LEE'S SUMMIT
MISSOURI
Development Services Department

Development Services Staff Report

File Number	PL2021-282 – REZONING from AG to RP-1, RP-4 & CP-2 and PRELIMINARY DEVELOPMENT PLAN – Blue Parkway mixed-density residential development
Applicant	Griffin Riley Property Group
Location	2840 SE Blue Pkwy
Planning Commission Date	September 23, 2021
Heard by	Planning Commission and City Council
Analyst	C. Shannon McGuire, Planner
Checked By	Hector Soto, Jr., AICP, Planning Manager Kent Monter, PE, Development Engineering Manager

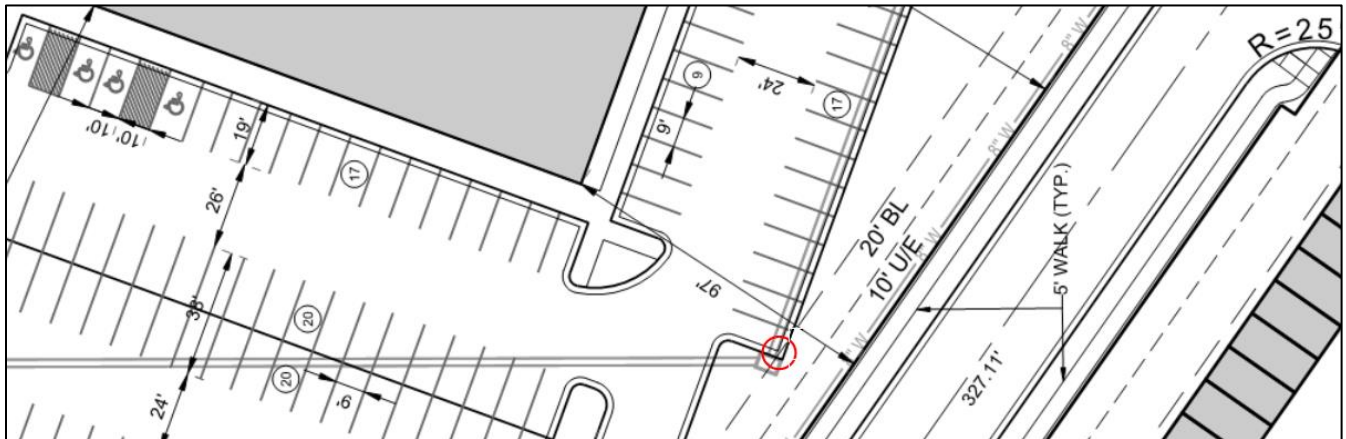
- **Required** - The UDO requires parking lots to be set back a minimum 20' from any public right-of-way.
- **Proposed** - The applicant proposes to reduce the required parking lot setback from 20' to 18' along the east property line adjacent to SE Heritage Street.
- **Recommended** – Staff supports the requested modification. The reduced setback is a result of the applicant's desire to maximize the available parking on the site. The encroachment will be adjacent to the proposed new collector street and the parking lot of the proposed apartments. For these reasons staff feels the request is reasonable.

10. A modification shall be granted to reduce the required parking lot setback from 20' to 18' along the east property line adjacent to SE Heritage Street.
